ORIGINATION FORM

Proposed Revisions to a Standard Plans Index

Index Number: 455-440

Index Title: Precast Concrete Sheet Pile Wall (CFRP/GFRP & HSSS/GFRP)

SECTION THRU BULKHEAD
(Showing Plastic Filter Fabric)

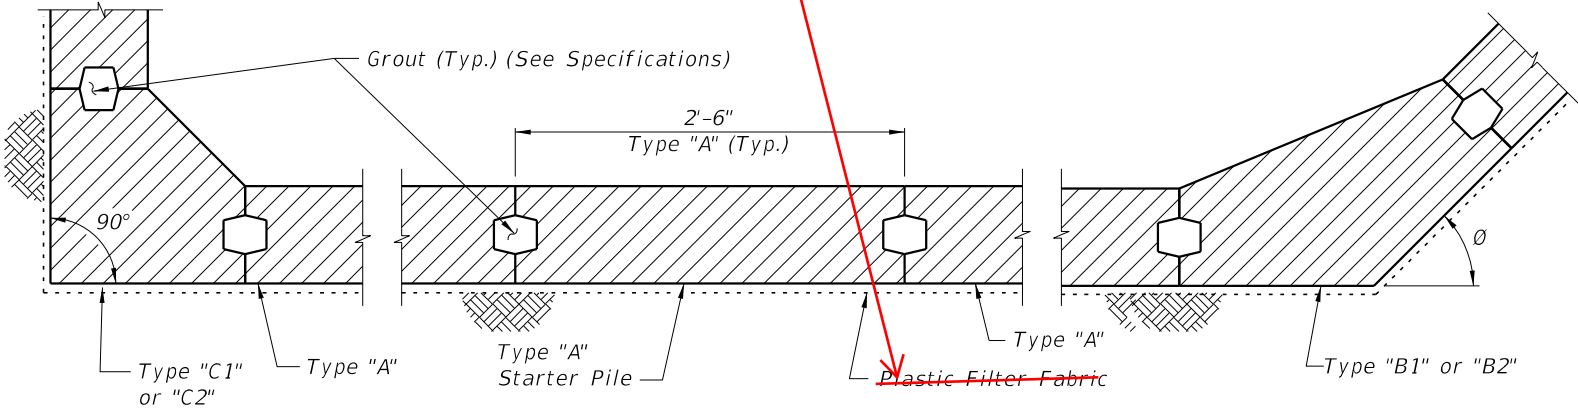
Sheet 1: Changed the "PLASTIC FILTER FRABRIC" Note in the SHEET PILE DESIGN CRITERIA AND NOTES to "GEOTEXTILE: Provide and install Type D-2 or D-3 geotextile in accordance with Specifications 514. Extend the geotextile to the bottom of the "X" dimension."; Changed all references of "Filter Fabric" or "Plastic Filter Fabric" to "Geotextile".

CHANGE: Geotextile

CHANGED:
Provide and install Type D-2 or D-3 geotextile in accordance with Specification 514. Extend the geotextile to the bottom of the "X" dimension.
